**TAMPA-HILLSBOROUGH COUNTY
EXPRESSWAY AUTHORITY**

Addendum No. 3

Renovation Services ~ THEA TMC

RFP O-01120

Phase 3A – 3rd Floor Demolition (Gray Area)

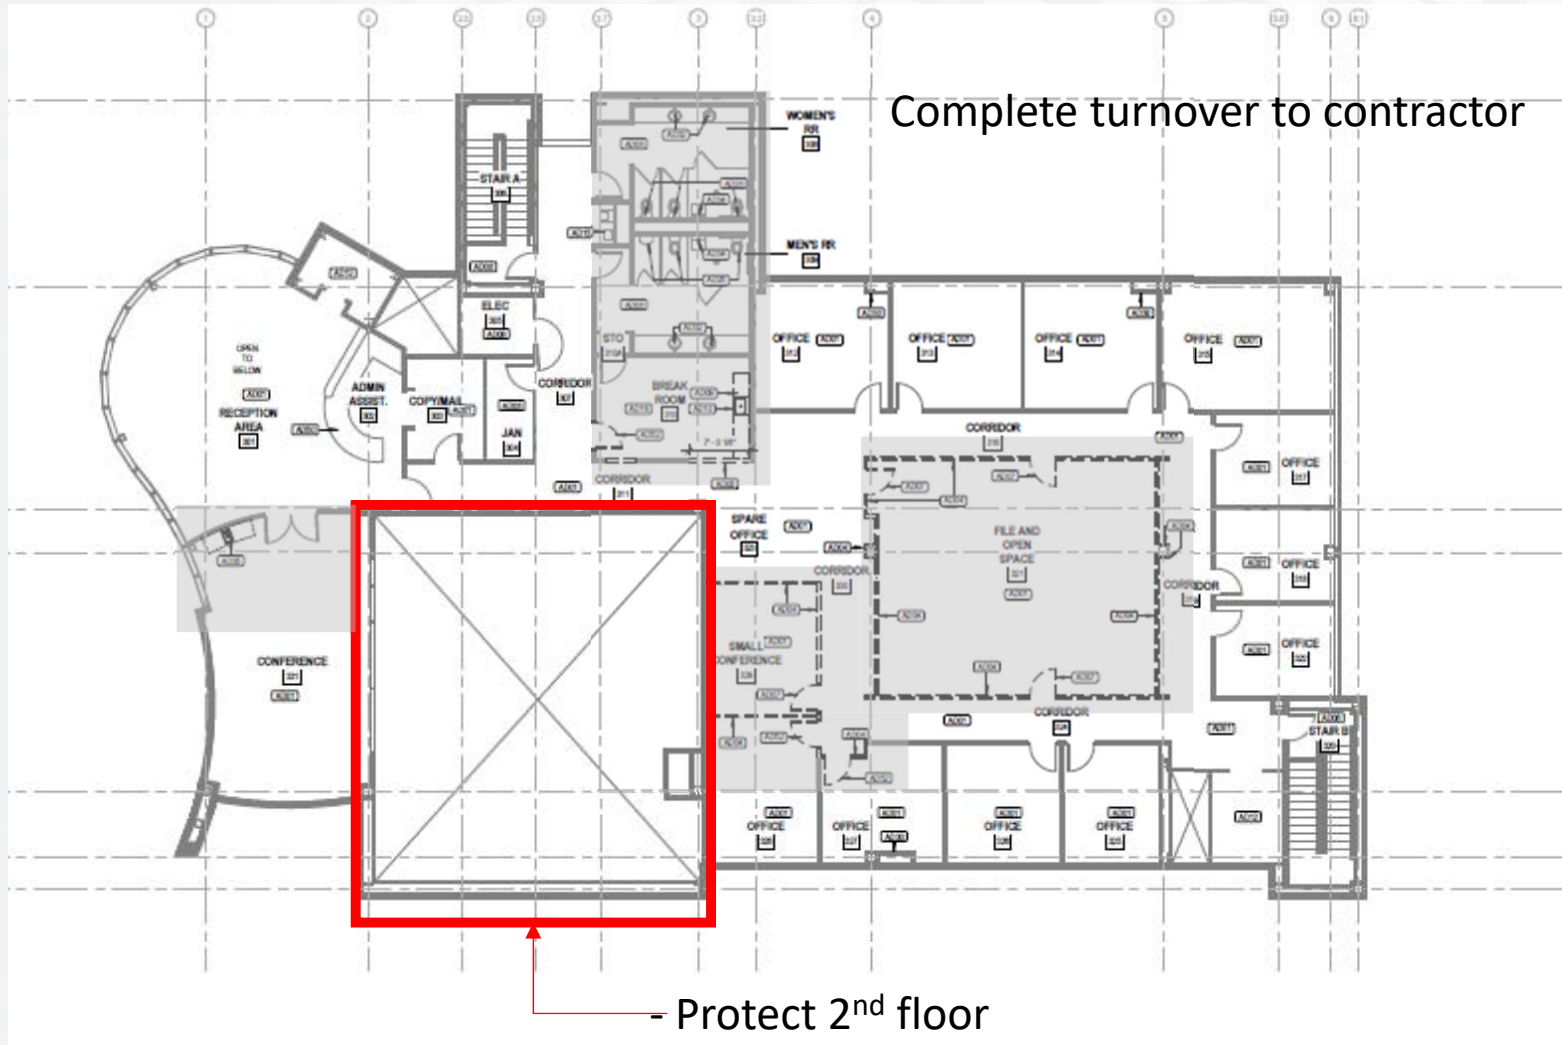
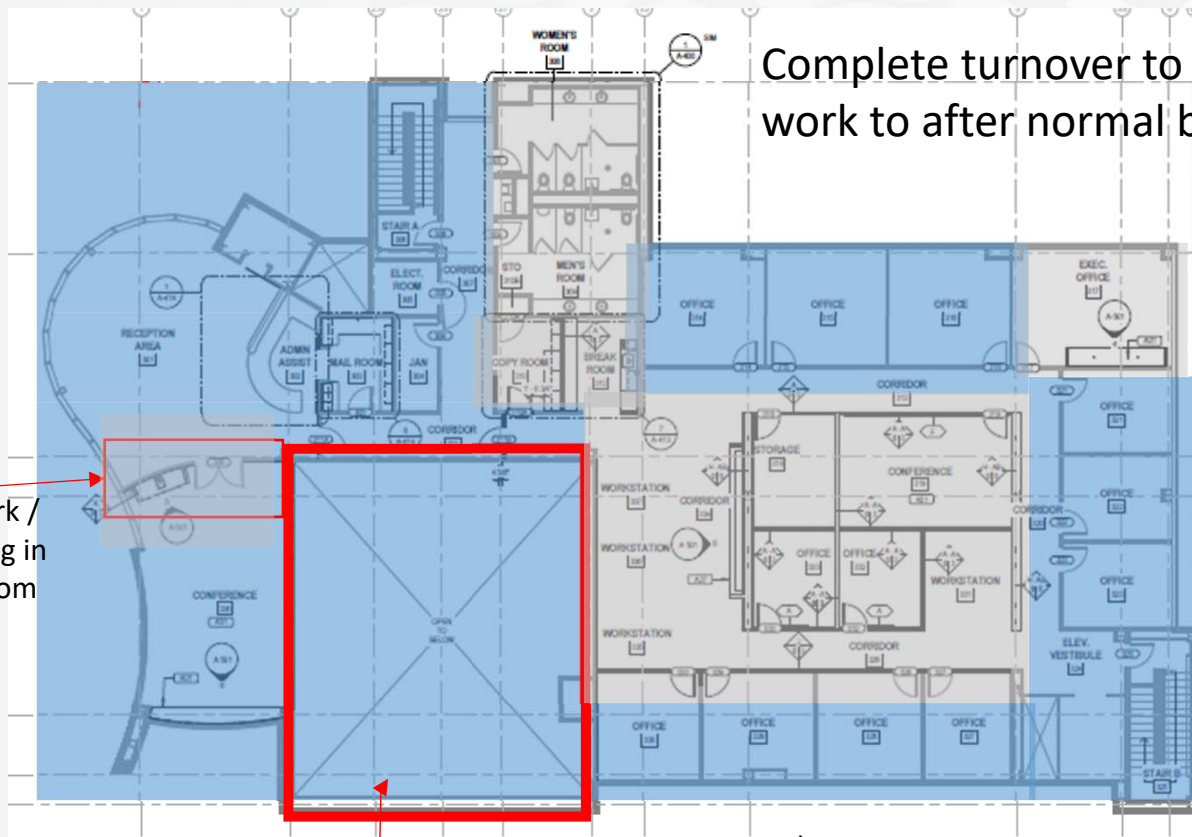
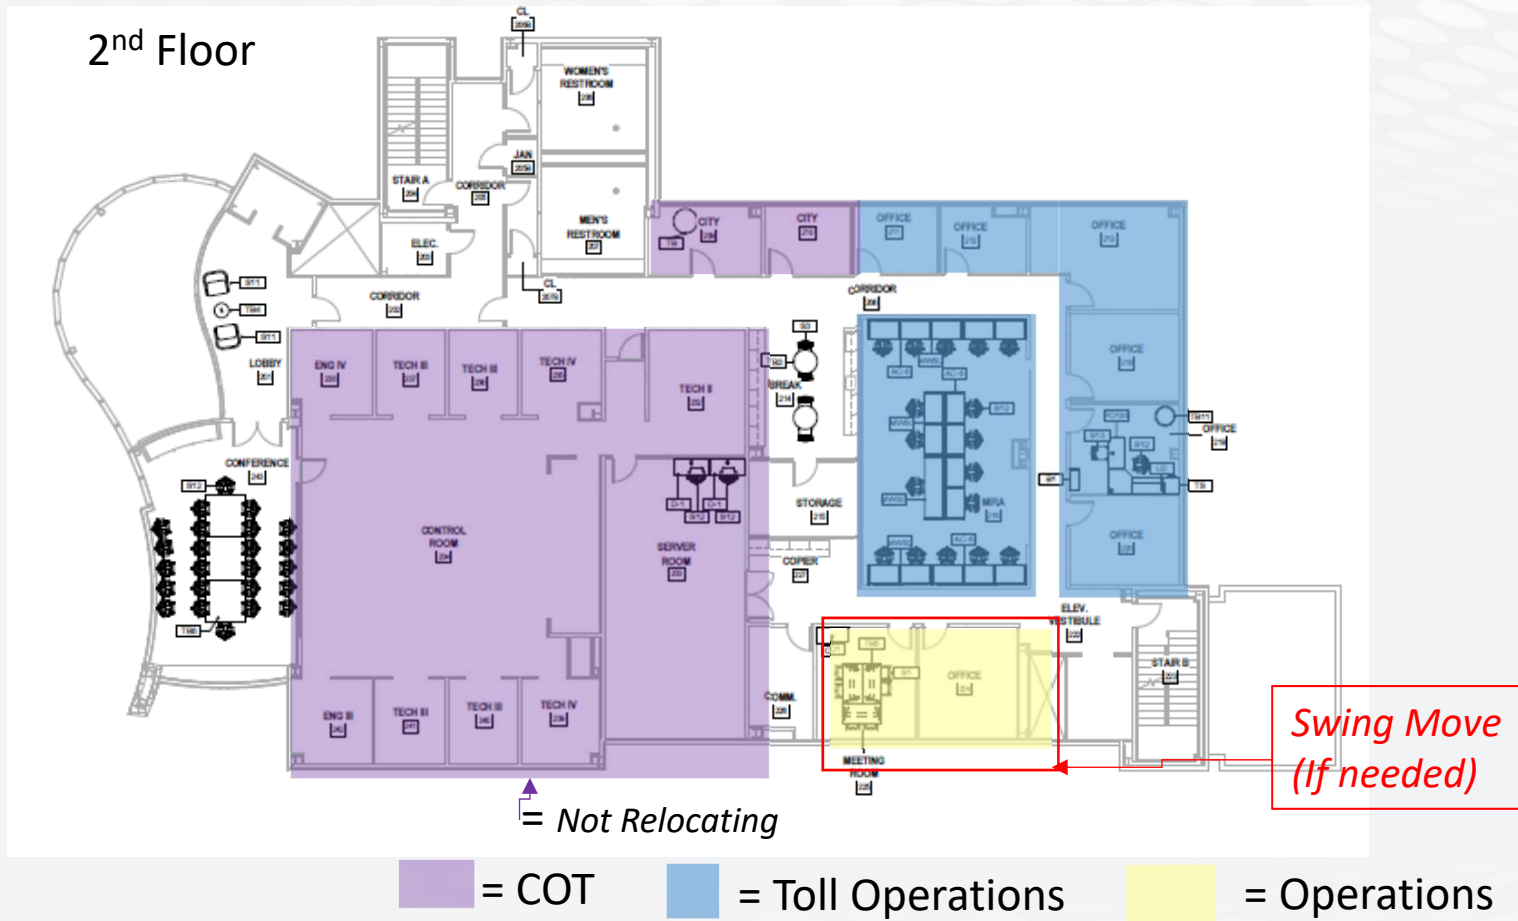
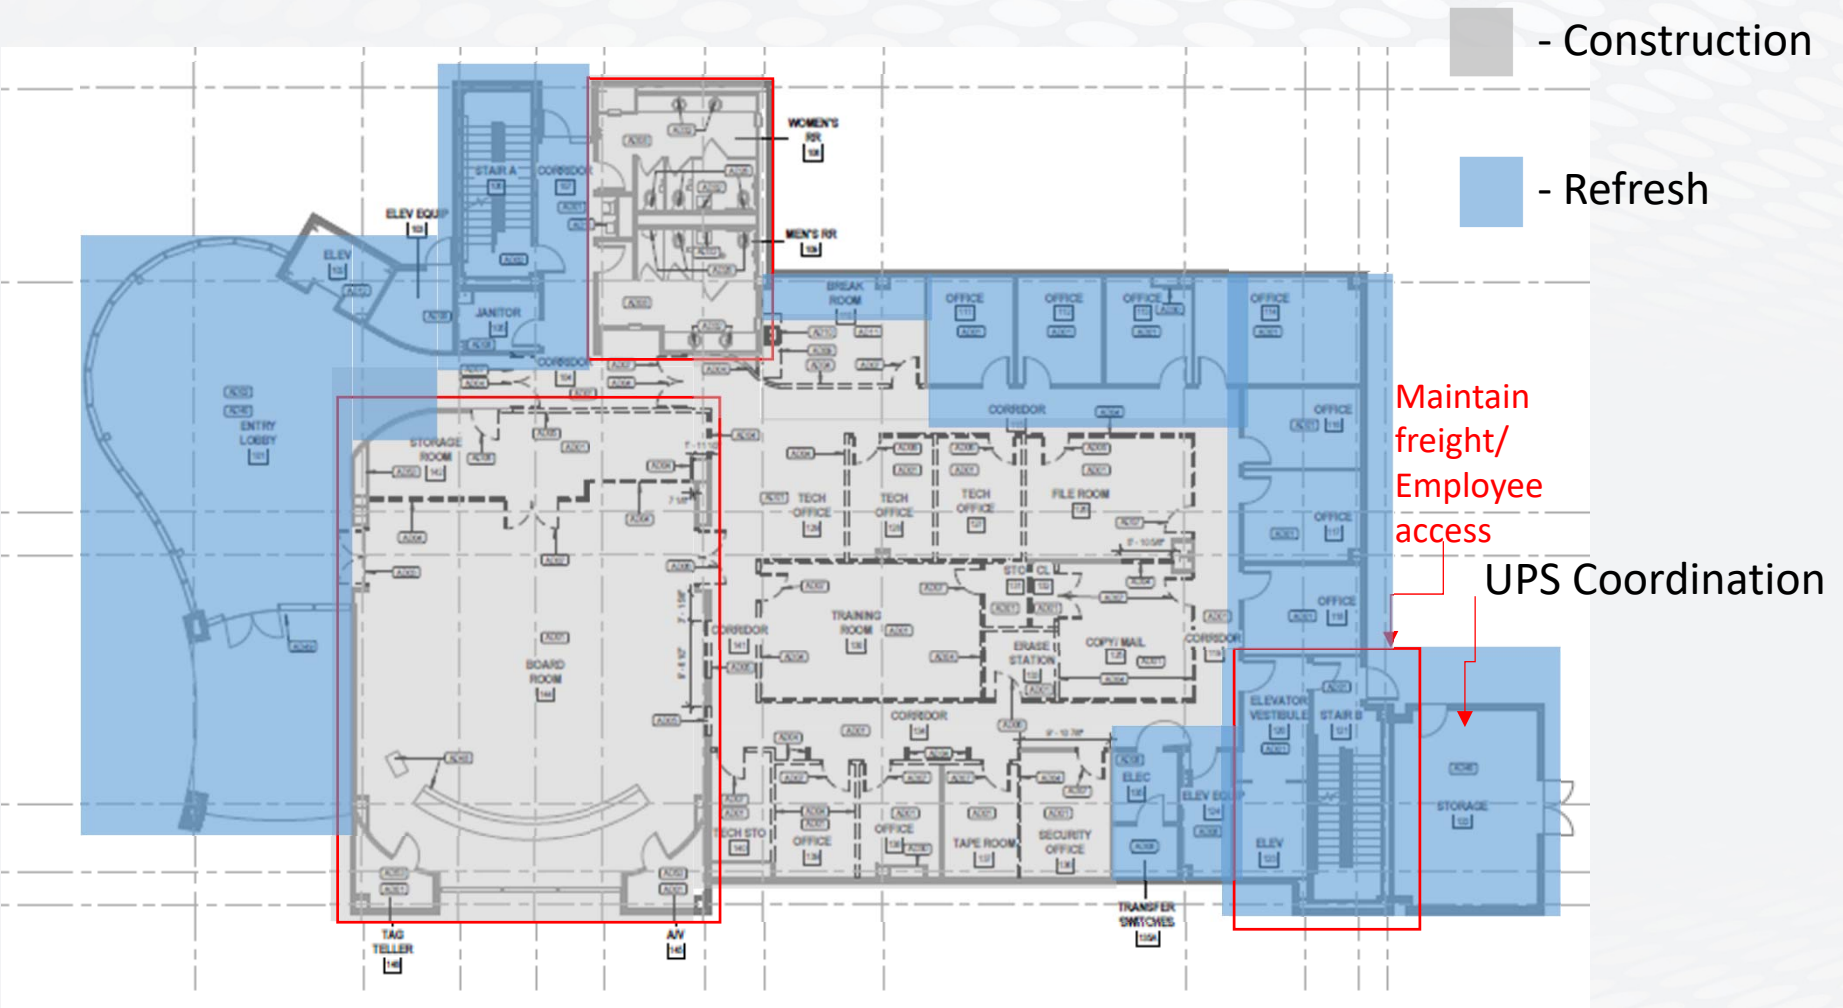
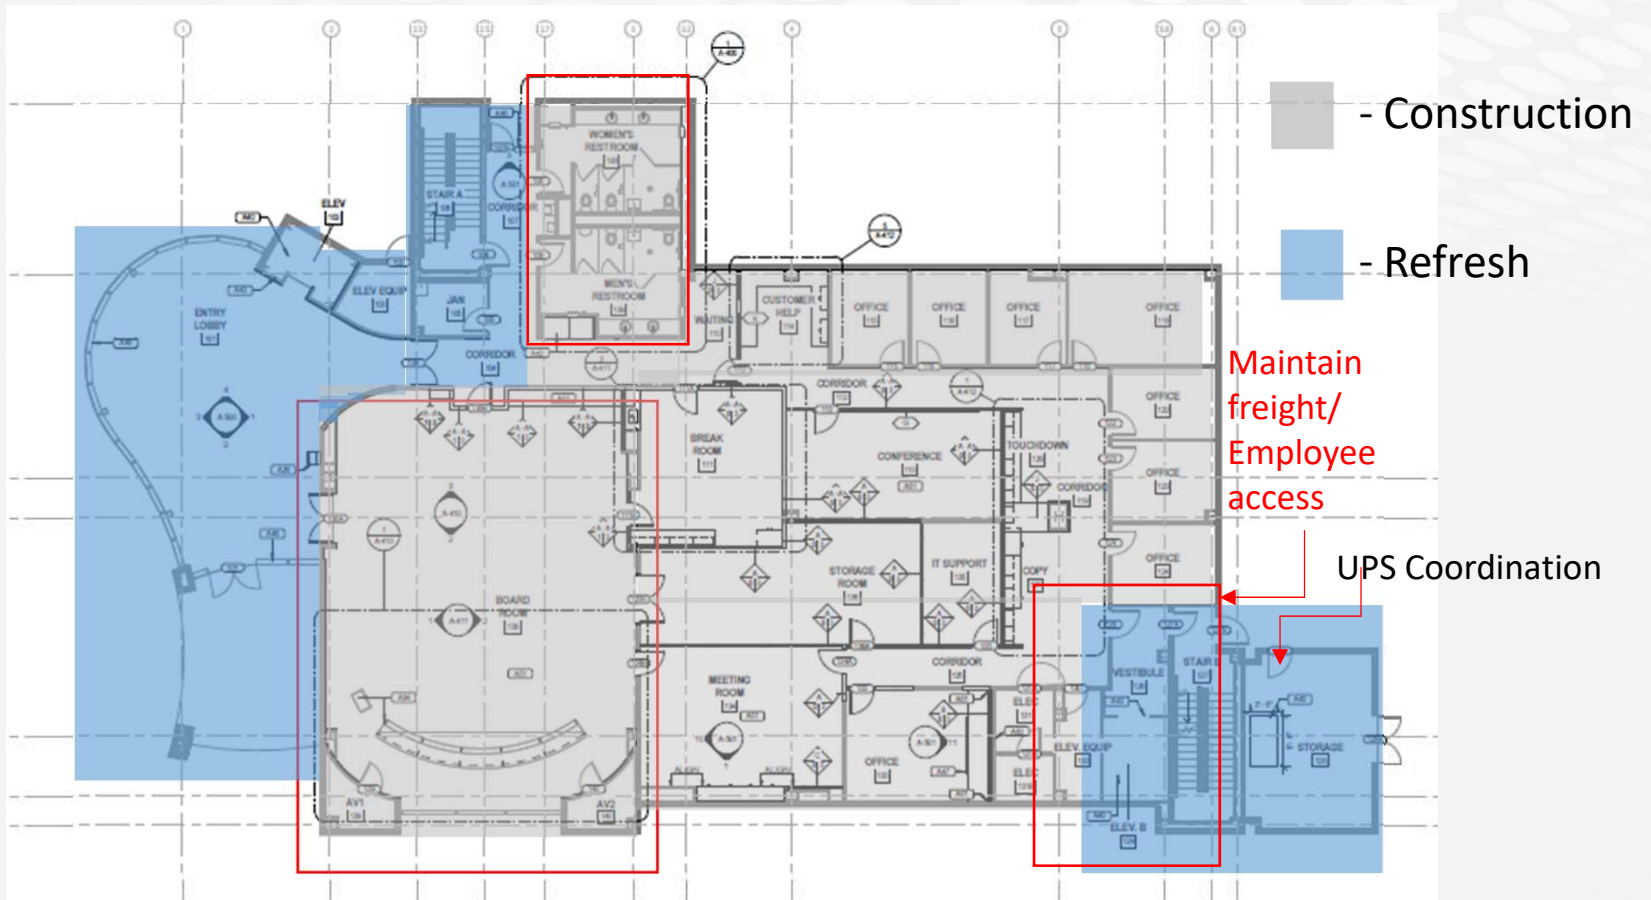
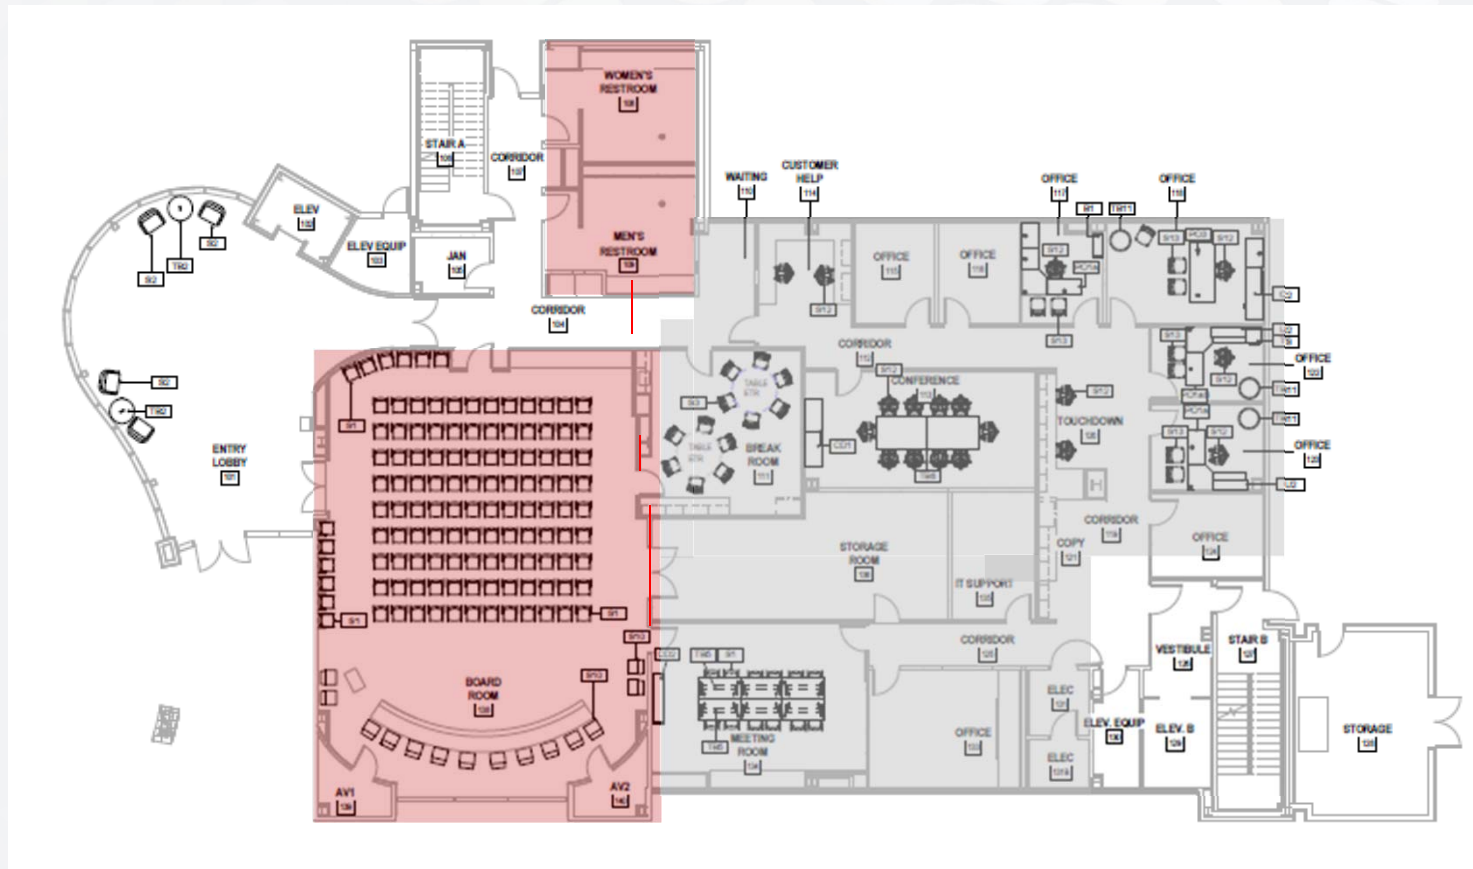
Alternate No. 4: Revised phasing plan to include staged access to the 2nd and 3rd floor renovation areas sequentially.

Response 70:	That is correct. Base bid assumes that the contractor would have access to perform work on all floors simultaneously. Schedule, means and methods are up to the contractor with some limitations regarding the TMC, server rooms and the like, which must remain in operation. The alternate 4 would require phasing of the renovation one floor at a time, likely beginning with the 2nd floor, then 3rd floor with 1st floor last. The first floor would be used as temporary "swing space" to accommodate THEA personnel during phased renovations. See Phasing Plan included with this Addendum
